63964

FILED
JUL 28 1998
STATE ENGINEER'S OFFICE

MAP TO ACCOMPANY APPLICATION TO CHANGE THE POINT OF DIVERSION, MANNER OF USE, AND PLACE OF USE OF A PORTION OF WATER HERETOFORE APPROPRIATED UNDER PERMIT NO. 22735 CERTIFICATE NO. 6938 BY DONALD J. RILY, ELIZABETH C. RILY AND HEATHER A. BOWMAN FROM UNDERGROUND IN THE PAHRUMP BASIN IN NYE COUNTY NEVADA

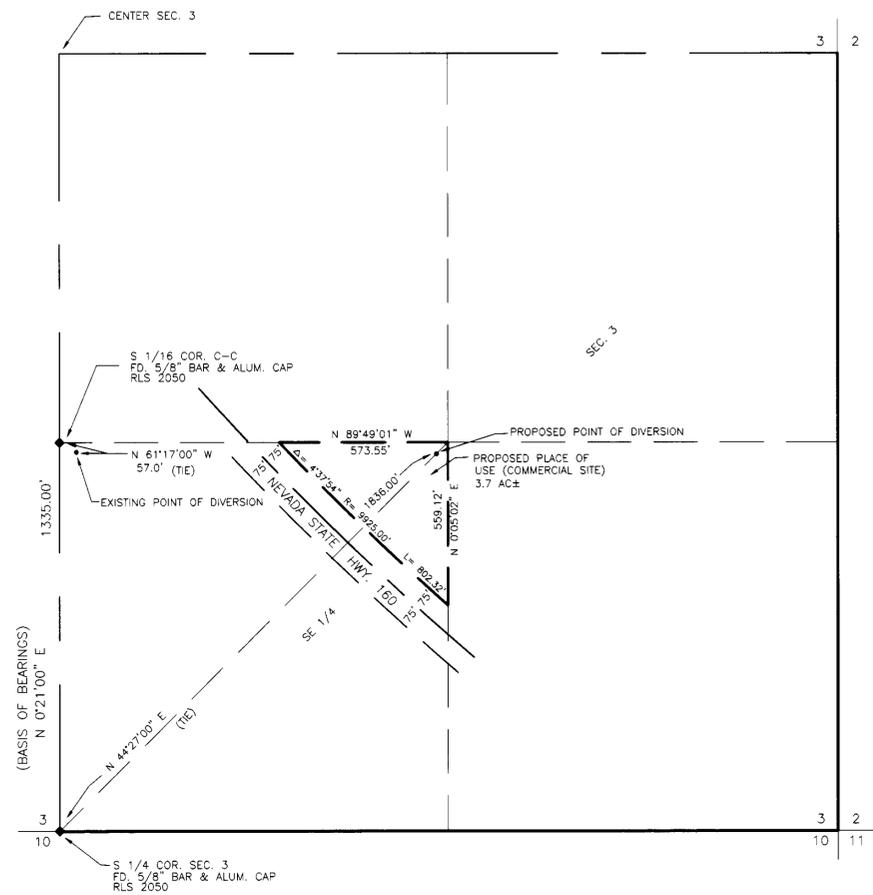
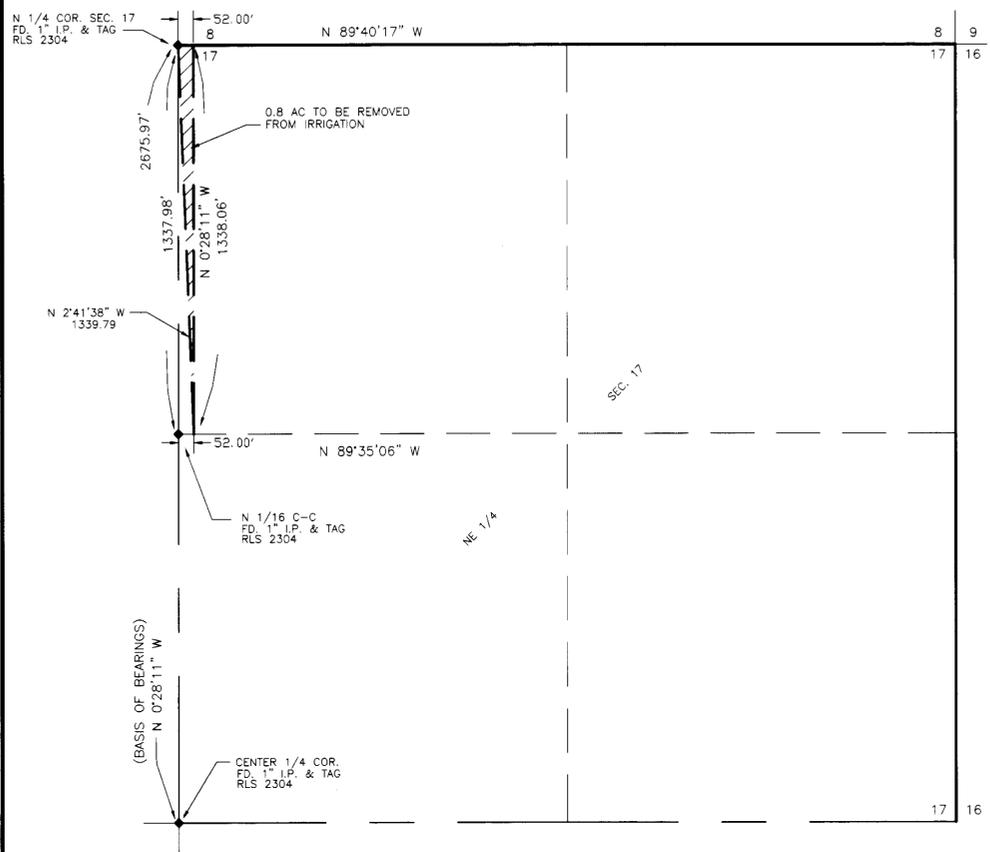
WKM 7-31-98 The name in lines 7 and 8 of the joint should be the names listed in the title block.

RAB 5-15-03 Acres stripped should be 0.769 Ac. and not 0.80 Ac. specified. Changing 52.0' stripped dimension to 50.02' will yield 0.769 Ac. stripped.
